Access Compliance Report Public Rights-of-Way (Curb Ramps)

Main Street: HEDWIG_RD Cross Street: WALLINGSFORD_RD Location: SE

ADA ID: RPRK220217153905 Ramp Type: Type 4 - Parallel Initial Pass/Fail: Fail Overall Compliance: No Severity Score: 15

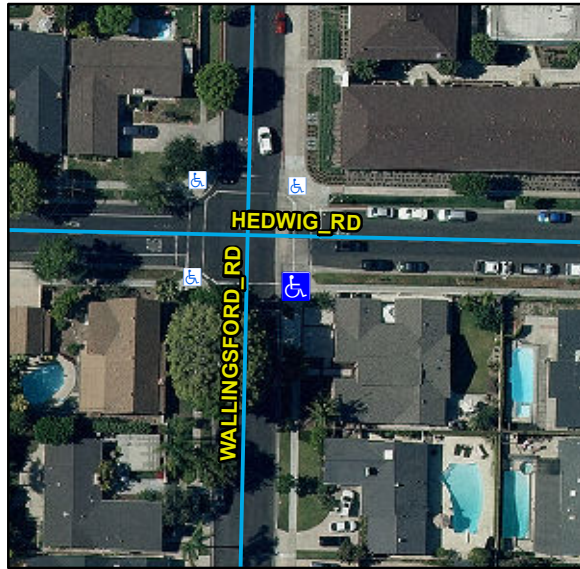
Compliance	Description	Data	Compliance	Description	Data
N/A	Ramp Length LT (in)	114	N/A	Ramp Length RT (in)	112
Yes	Ramp Width LT (in)	120	Yes	Ramp Width RT (in)	120
Yes	Ramp Run Slope LT (%)	4.6	Yes	Ramp Run Slope RT (%)	3.5
No	Ramp Cross Slope LT (%)	7	No	Ramp Cross Slope RT (%)	3.1
N/A	Landing Present	N/A	N/A	DWS Provided	N/A
N/A	Landing Length (in)	N/A	N/A	DWS Contrast	N/A
N/A	Landing Width (in)	N/A	N/A	DWS Length (in)	N/A
N/A	Landing Run Slope (%)	N/A	N/A	DWS Full Width	N/A
N/A	Landing Cross Slope (%)	N/A		DWS Offset Type	N/A
N/A	Landing Movement Obstructed?	N/A	N/A	DWS Offset Left (in)	N/A
	Landing Movement Type	N/A	N/A	DWS Offset Right (in)	N/A
N/A	Landing Shared	N/A			
N/A	Clear Space	Yes			
N/A	Clear Space To Crosswalk (in)	48			
N/A	Marked Crosswalk 1	Yes	N/A	Marked Crosswalk 2	Yes
	Crossing 1 Direction	N		Crossing 2 Direction	NW
	Marked Crosswalk 1 Width (in)	120		Marked Crosswalk 2 Width (in)	120

N/A	Ramp Inside Crosswalk 1	Yes	N/A	Ramp Inside Crosswalk 2	Yes
	Crossing 1 Slope (%)	2.3		Crossing 2 Slope (%)	4.7
	Crossing 1 Cross Slope (%)	1.6		Crossing 2 Cross Slope (%)	0.1
N/A	Gutter Ponding	N/A	Yes	Curb Slope	2.1
No	Gutter Lip Height (in)	2.1		Road Run Slope (%)	2.1
N/A	Gutter Run Slope (%)	N/A		Road Cross Slope (%)	0.8
N/A	Gutter Cross Slope (%)	N/A	No	Perpendicular Joint Present	No
Yes	Overall Surface Condition	Acceptable			
	Cross Gutter Present?	Yes		Spandrel Present?	Yes
	Replace Cross Gutter?	No		Replace Spandrel?	No

Remove & Replace Curb Ramp With Two New Directional Ramps or Equivalent. Grind Gutter Lip.

R204.3, R304.5.3, R302.7.2, STD 1115
